This software updates or alters the functions and features noted below. The instructions and information that follow are meant as a supplement to the original instruction manual that accompanied the transmitter. Please refer to the original instruction manual where applicable, but replace the steps indicated below with these instructions. Please check to ensure that the update has been installed.

1. Add Model ID

This software updates or alters the functions and features noted below. The instructions and information that follow are meant as a supplement to the original instruction manual that accompanied the T18SZ/T16SZ/FX-36 transmitter. Please refer to the original instruction manual where applicable, but replace the steps indicated below with these instructions. Please check to ensure that the update has been installed.

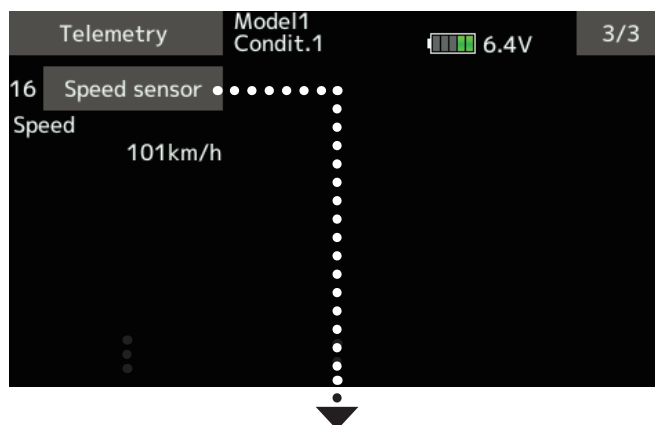
◆ How to display the Airspeed sensor screen.

- ① [Linkage menu] → [Telemetry]

◆ Speed sensor screen

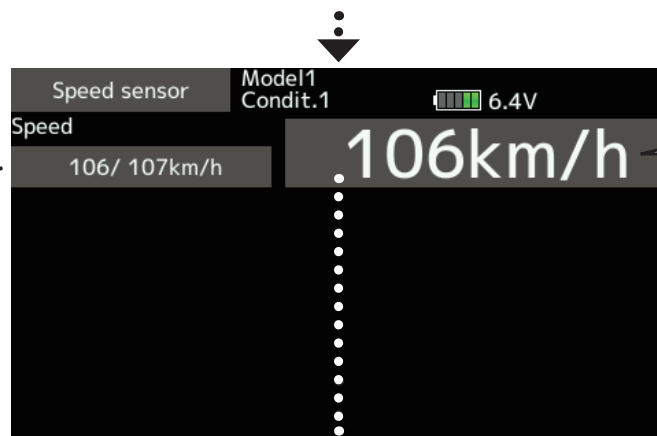
Max. and min. values since the power was turned ON will display.

◆ Alarm setting

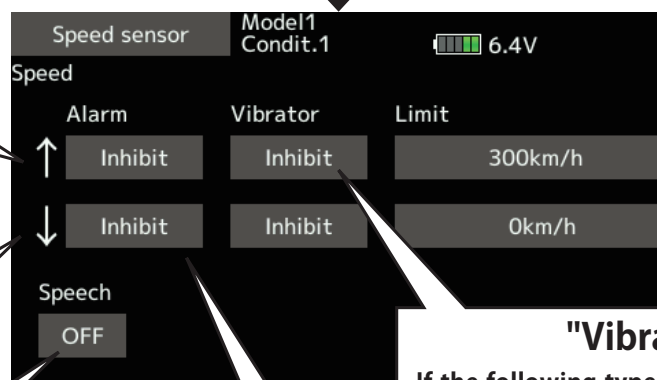
↑ An upward arrow indicates the alarm will sound when the speed reaches above your set value.

↓ A downward arrow indicates the alarm will sound when the speed reaches below your set value.

The ON/OFF switch of Speech is chosen.

A setup of the speed on which the alarm operates.

Alarm is chosen from Buzzer, Voice, and Inhibit.

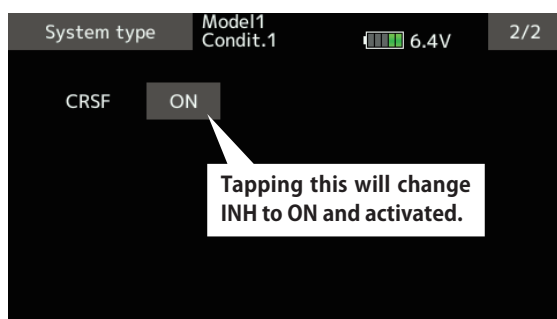
The T18SZ/T16SZ/FX-36 has been made compatible with the CRSF (TBS) protocol.

- ① [Linkage menu] → [System Type] → [Page 2/2] is opened from the transmitter.

Tapping this will change INH to ON and activated.

- ② Tap the "CRSF" button to [ON]. A signal conforming to the CRSF standard is output from the S.BUS setting connector (S.I/F) of the transmitter.

Sensor type selection screen

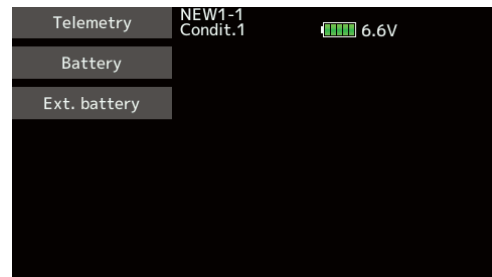
The number of telemetry data which is displayed to Telemetry display screen is extended. It is 16 items (4 pages) maximum.

You can choose which type of sensor to displays. Tap the sensor type.

If you do not want to display telemetry data on the telemetry monitor screen, select "---".

5. Butterfly Elevator setting (Glider)

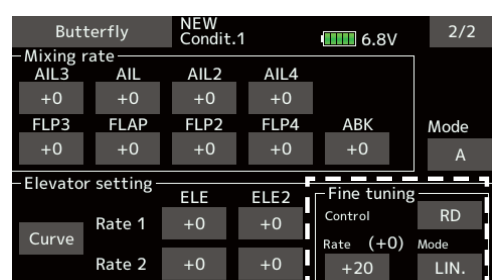
Added fine tuning function to butterfly elevator setting.

*When Flying wing type, it was made not to display Elevator setting.

6. Butterfly mixing mode (Glider)

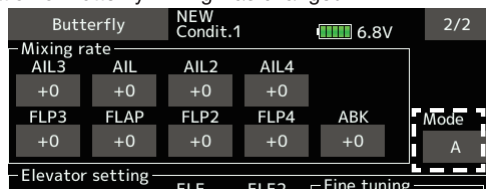
The operation of Butterfly mixing was changed.

Mode A, mode B selection added.

• Mode A

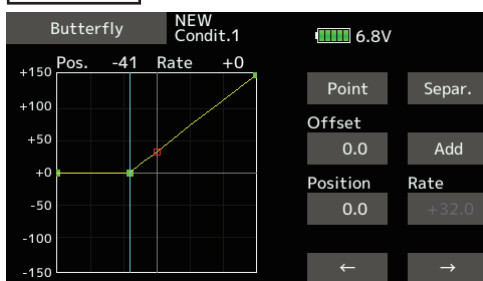
- The butterfly operation direction is reversed at the neutral position (50%) of the throttle stick.

The direction of butterfly motion is reversed.

• Mode B

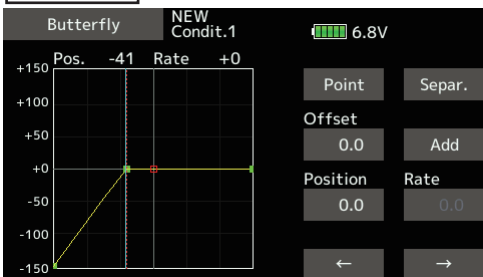
- It does not reverse at the neutral position, so you can set the butterfly operation start point with the full stroke of the throttle stick.

The direction of butterfly motion is not reversed.
